10 May 2017

Re: Western Sydney Stadium - Response to Stage 2 DA Comments

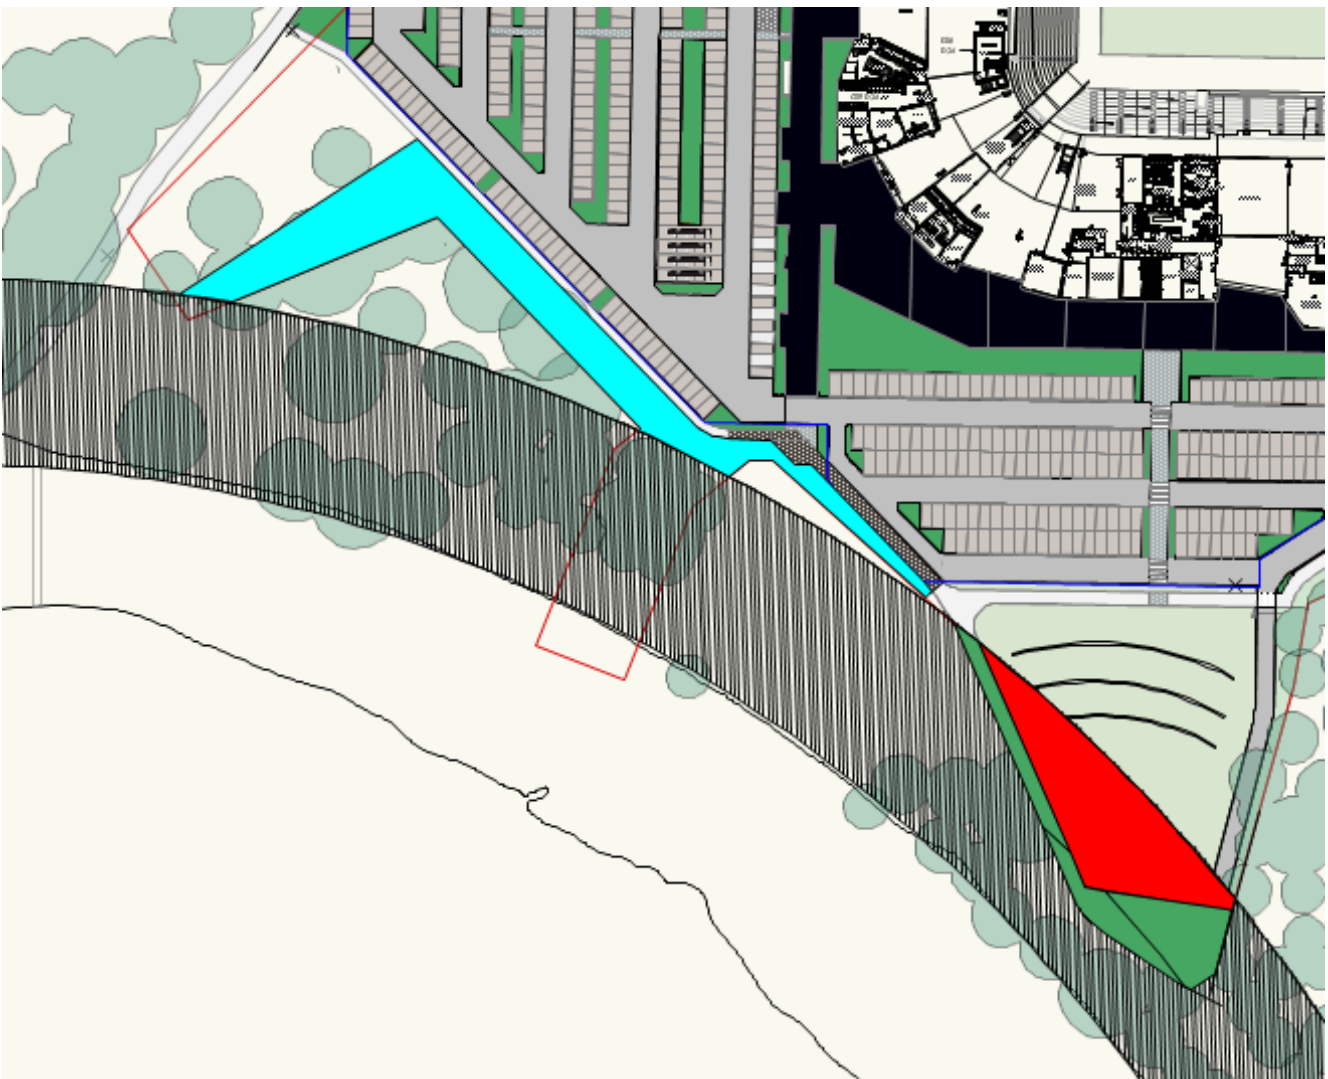
The development should be carried out in accordance with the DPI Water Guidelines for Controlled Activities on Waterfront Land, including:

- ***Where reasonable and feasible, the siting of the development should be located outside the riparian corridor within the subject site. Should nonriparian uses encroach into the outer 20m wide riparian area, an equivalent riparian offset area should be provided within the site which is connected to the riparian corridor;***

However, the City of Parramatta Council has indicated that a wider 40m riparian buffer is required,

“The Parramatta River forms the western boundary of the site and is a 4th Order Watercourse (Strahler stream ordering system) requiring a minimum 40m vegetated riparian zone (VRZ) from the ‘top of bank’ in accordance with the NSW Office of Water ‘Guidelines for riparian corridors’.”

Clarity is sought on whether a 20m or 40m riparian buffer is appropriate in this situation.

The 20m wide riparian buffer and its location in relation to the site works is shown in the diagram below.

The encroachment and equivalent offset areas are located and calculated as follows, and is also shown in the diagram below.

-  - Riparian zone conflict with site works area – 13.7m²
-  - Riparian zone conflict with works outside of site area – 198m²
-  - Riparian offset area – 215m²

A 40m wide riparian buffer has been identified, and the associated encroachments and offsets calculated. A vegetation offset area has been identified which is,

- located within the Western Sydney Stadium site boundary,
- set away from activity areas,
- adjacent to, and part of a steep embankment with existing native forest,
- connected to the riparian corridor.

- Riparian zone conflict with site works area – 960 m²
- Riparian zone conflict with works outside of site area – 605m²
- Riparian offset area – 1575m²
